From: Richard Castro-Parker
Sent: 23 September 2019 12:58
To: Daniel Vick
Subject: FW: BE/139/18/PL - Innovation Centre Beeding Close

From: Richard Castro-Parker
Sent: 23 September 2019 12:19
To: Laura Gibbons <Laura.Gibbons@arun.gov.uk>
Cc: Juan Baeza <Juan.Baeza@arun.gov.uk>; Samantha Lee [REDACTED]
Subject: FW: BE/139/18/PL - Innovation Centre Beeding Close

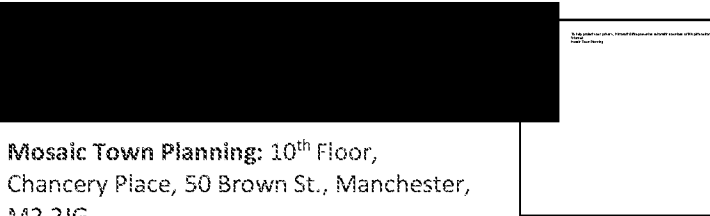
I still am struggling to distinguish between lines. Please can different line types be used, rather than all very similar colours. Please can gullies, manholes, and linear drainage channels be clearly labelled.

Please can the applicant submit clearer plans of the proposed surface water drainage arrangement. I.e. different line types used, rather than all very similar colours. Please can gullies, manholes, and linear drainage channels be clearly labelled.

The colour of the lines have been changed and it is very different from each other in my screen. Please therefore let me know if Laura is still unable to distinguish them. I've also got confirmation from the client that they already have someone booked in to have the drainage cleaned.
